Transmittal Form: Plat Paper Check

From: Colin Cortes, AICP, CNU-A, Senior Planner Date: January 17, 2024
Cc: Chris Kerr, Community Development Director; Curtis Stultz, Public Works Director; Dago Garcia, P.E., City Engineer; Roy Reyes, Project Engineer; [Peyton James](#), Assistant Planner, Pacific Community Design (PCD); [Noah Anderson](#), Land Acquisitions Analyst, LGI Homes; [Alex Bertorelli](#), Land Development Manager, LGI Homes; Vanessa Lewis, Land Development Manager, LGI Homes; [Craig Larson](#), Project Engineer, PCD; [Travis C. Jansen](#), PE, PLS, Survey Manager, PCD ("Paper check" no. 3)
Re: Woodburn Subdivision Final Plat App FSUB 23-02 (County SP23-007) Dove Landing PUD / (County "Dove Landing"; related to City master/parent land use case file no. ANX 2020-03

Memo

Re: Dove Landing Playground Safety Audit and Park Amenity Walk

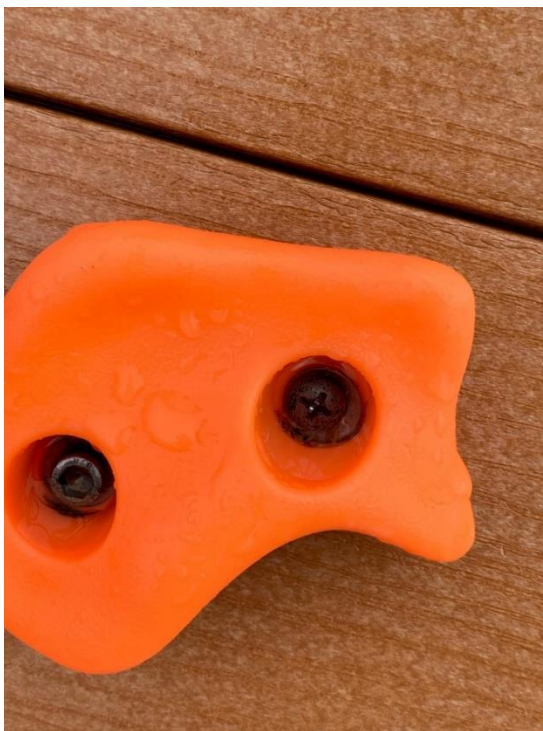
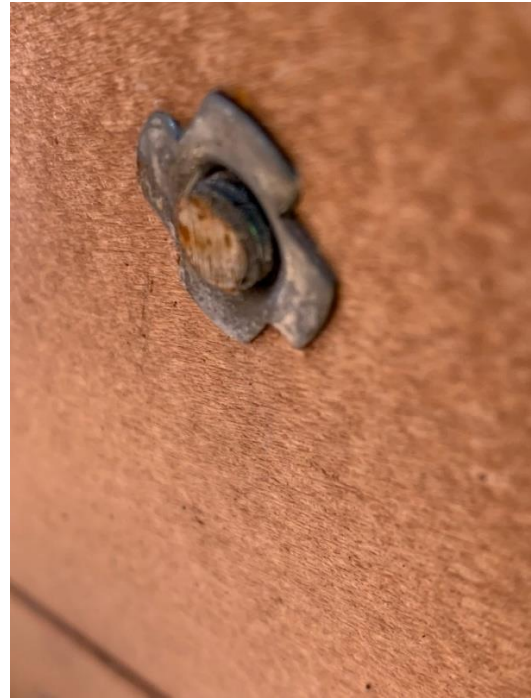
- **3 head entrapment hazards were identified. (view video links below)**
 - The top and bottom opening built into the Tic Tac Toe activity wall has gaps in it that allow the torso probe to pass but not the head probe.
 - A barrier wall opposite the activity wall also has a gap between the bottom of the barrier wall and the play platform. Again, the torso probe fits through, but the head probe does not. If the torso fits, then the head probe must fit as well.
